**Minimum Operational Performance Standards for
1090 MHz Extended Squitter
Automatic Dependent Surveillance – Broadcast (ADS-B)
and
Traffic Information Services – Broadcast (TIS-B)**

Draft of Change 1

RTCA DO-260A, Change 1
June 27, 2006
Modifies RTCA/DO-260A

Figure 2-21: Report Assembly Airborne State Transition Diagram

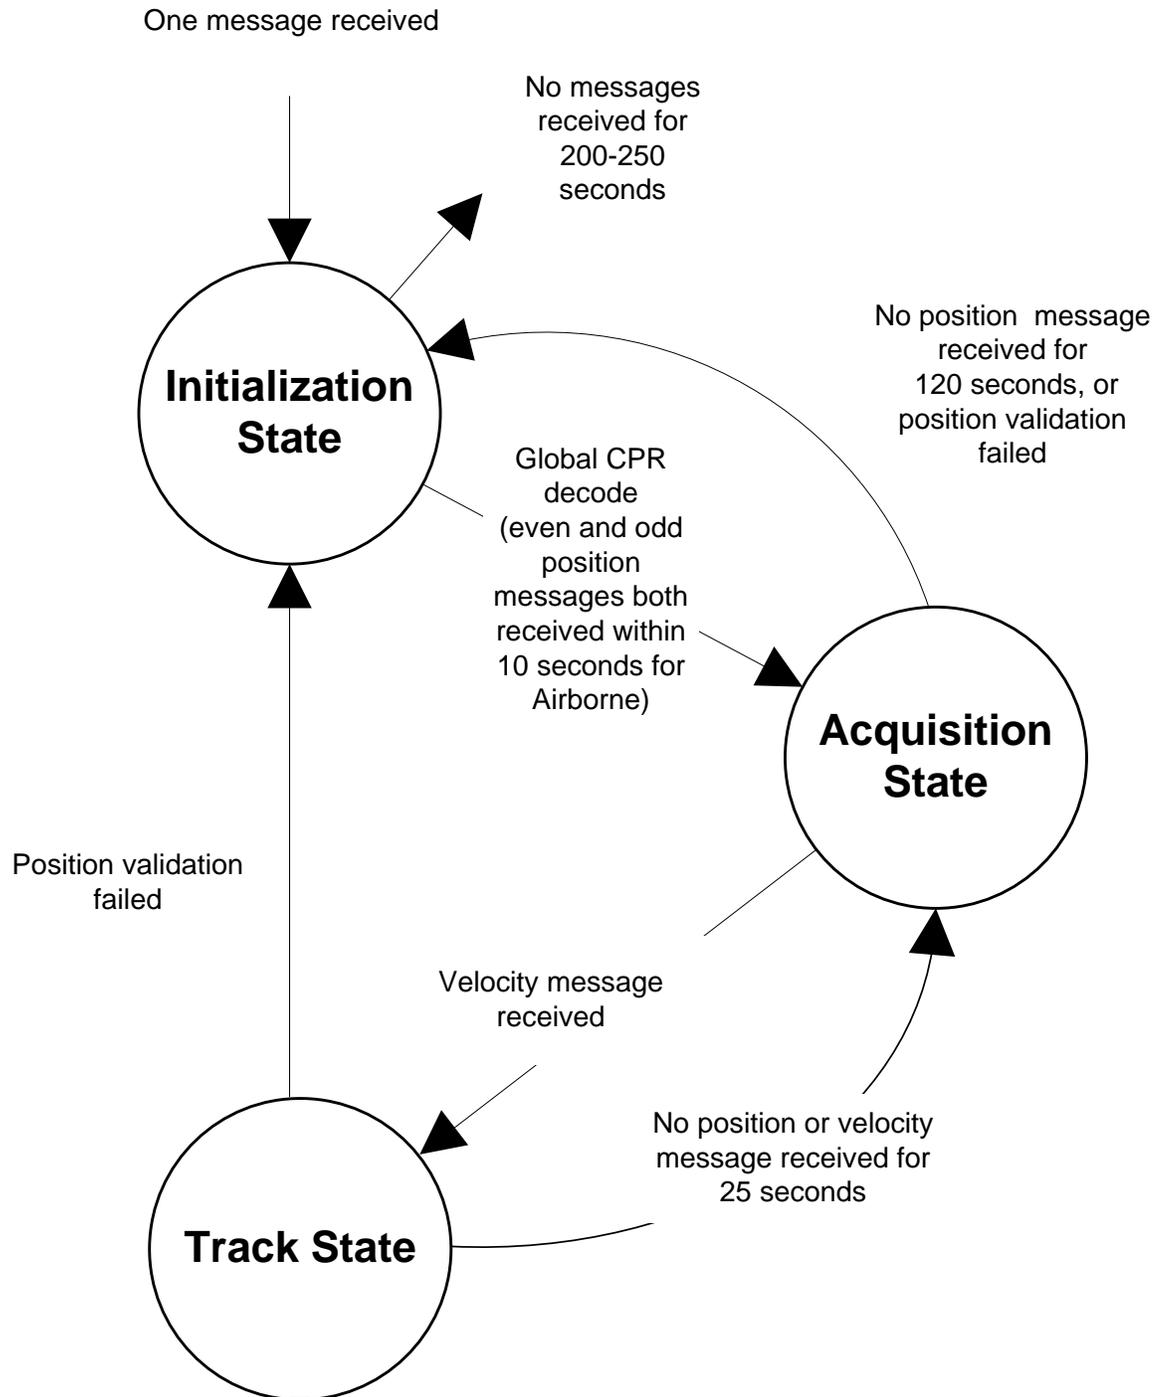
(1.27) In RTCA/DO-260A, in section §2.2.10.1.1, replace Figure 2-21 with the following:
